Access Compliance Report

Intersection ID: 30021	Main Street: DAY_LILLY_LN	Cross Street: SUMMER_MEADOW_CT	Location: SE
ADA ID: 7EB52BCBE698	Ramp Type: PerpDiag	Initial Pass/Fail: Fail	Overall Compliance: No
Severity Score: 21.25			
Codes/Mitigation Info/Possible Solution		Field Measurements/Component Compliance

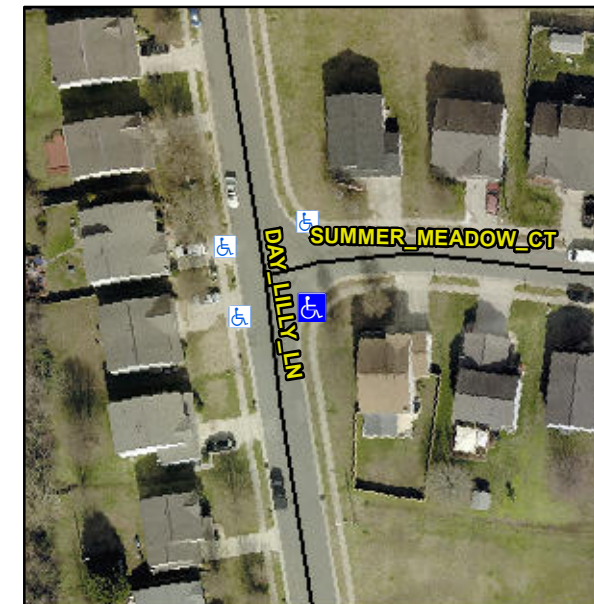
Not Found, R304.5.1, R304.2.2

Compliance	Description	Data	Compliance	Description	Data
N/A	Ramp Length (in)	47.5	No	Ramp Slope (%)	8.4
No	Ramp Width (in)	46.5	Yes	Ramp XSlope (%)	1.3
N/A	Flare Type LT	N/A	N/A	Flare Type RT	N/A
N/A	Flare Slope LT (%)	N/A	N/A	Flare Slope RT (%)	N/A
N/A	Flare Traversable LT?	N/A	N/A	Flare Traversable RT?	N/A
N/A	Landing Length (in)	N/A	N/A	DWS Provided?	N/A
N/A	Landing Width (in)	N/A	N/A	DWS Contrast?	N/A
N/A	Landing Slope (%)	N/A	N/A	DWS Length (in)	N/A
N/A	Landing X Slope (%)	N/A	N/A	DWS Full Width?	N/A
N/A	Landing Curb? (Y/N)	N/A	N/A	DWS Offset (in)	N/A
N/A	Shared Landing?	N/A			
N/A	Gutter Ponding?	N/A	N/A	Gutter Slope (%)	N/A
N/A	Gutter Lip Ht (in)	N/A	N/A	Gutter X Slope (%)	N/A
N/A	Painted X Walk1?	No	N/A	Painted X Walk2?	No
	X Walk 1 Direction	To NW		X Walk 2 Direction	To NE
N/A	X Walk 1 Width (in)	N/A	N/A	X Walk 2 Width (in)	N/A
	X Walk 1 Slope (%)	2.6		X Walk 2 Slope (%)	1.4
	X Walk 1 X Slope (%)	3.2		X Walk 2 X Slope (%)	4.3

Remove & Replace Curb Ramp With Two New Directional Ramps or Equivalent.
